**SB-18-019 DTC P2458 WORKSHOP MANUAL
CORRECTION**

**GROUP: SERVICE MANUAL UPDATE
BULLETIN NO: SB-18-019
DATE: 9-5-2018
REF: SB-A-17-031**

SUBJECT VEHICLES: Conventional Trucks equipped with an J08E and COE Trucks equipped with an J05E.

Workshop manual correction of DTC P2458 and added cleaning carbon procedure to troubleshooting.

3

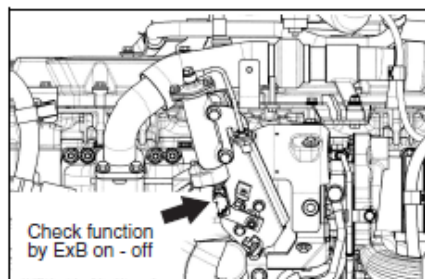
Inspect the aftertreatment fuel injector housing is for soot clogging.

1. Remove the aftertreatment fuel injector housing.

2. Clean the aftertreatment fuel injector housing.

3. Reinstall the aftertreatment fuel injector housing.

If excessive carbon buildup has removed from the exhaust pipe, fuel injector housing, or aftertreatment fuel injector, clear the DTC and reset for normal DPR regeneration. If problems persist, go to step 4.

1. CLEANING CARBON

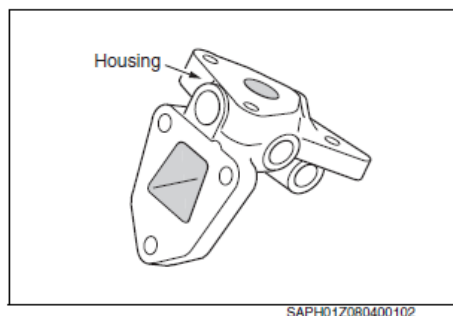
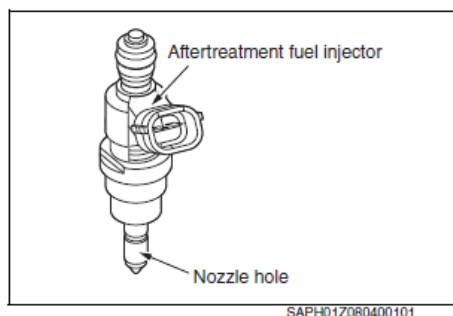
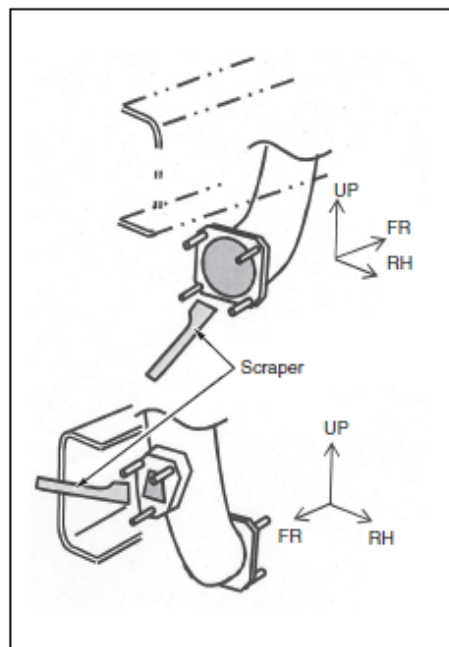
- The aftertreatment injector and housing will be cleaned with a strong alkaline carbon cleaner. Use of safety glasses, rubber gloves, and garment protection is mandatory. Avoid contact with eyes, skin, and clothing. Failure to protect your eyes and skin may result in serious burn injuries. Rinse with running water immediately if the carbon cleaner contacts your skin. If the carbon cleaner contacts your eyes, thoroughly rinse with running water and consult a physician immediately.
- Do not allow the carbon cleaner to contact resin parts, terminals, or the rubber O-ring on the aftertreatment injector. Immediately rinse the carbon cleaner off with water if it contacts these portions of the aftertreatment injector.

- (1) Spray the carbon cleaner on the nozzle tip of the aftertreatment fuel injector. Leave the carbon cleaner on the tip of the injector until the carbon is dissolved. Once the carbon is dissolved, rinse the injector tip with water then blow it dry using compressed air.

- DO NOT touch the tip of the injector nozzle with your hands. Do not wipe the nozzle with a rag or use a scraper to remove carbon from the nozzle tip.
 - DO NOT apply force to the electrical connector of the injector to avoid breakage.
- (2) Spray the carbon cleaner into the injector housing and allow it to soak until the carbon is dissolved. Rinse the housing with water then blow it dry using compressed air.

2. CLEANING OF EXHAUST PIPE No.1 (ATC)

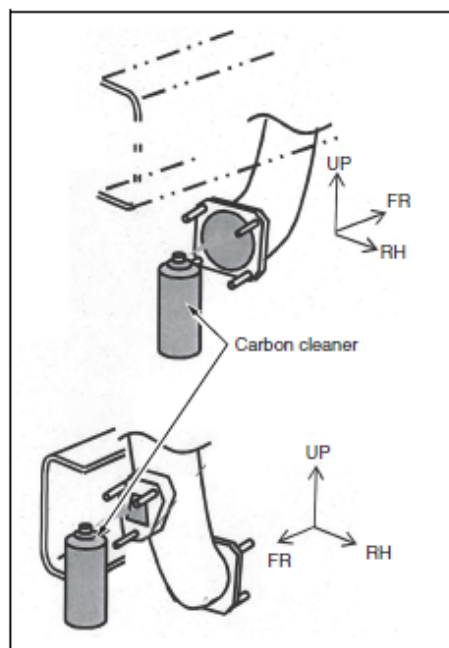
- (1) Remove the housing from the exhaust pipe No.1 (ATC).
Reference: FUEL SYSTEM (J08E), AFTERTREATMENT FUEL INJECTOR, OVERHAUL, REMOVING THE AFTERTREATMENT FUEL INJECTOR (Page EN04-58)
- (2) Remove the exhaust pipe No.2 from the exhaust pipe No.1 (ATC).
Reference: EXHAUST SYSTEM (J08E), EXHAUST PIPE AND MUFFLER UNIT, OVERHAUL, IMPORTANT POINT -DISMOUNTING (Page EN04-13)
- (3) Use a scraper to remove carbon buildup from all openings on the exhaust pipe No.1 (ATC).

- (4) After removing the carbon, clean the inside of the exhaust pipe No.1 (ATC) using a carbon cleaner. Allow the carbon cleaner to soak until the carbon is dissolved. Rinse the cleaner off with water and blow it dry using compressed air. Reinstall the exhaust pipe No.1 (ATC), housing, and aftertreatment injector.
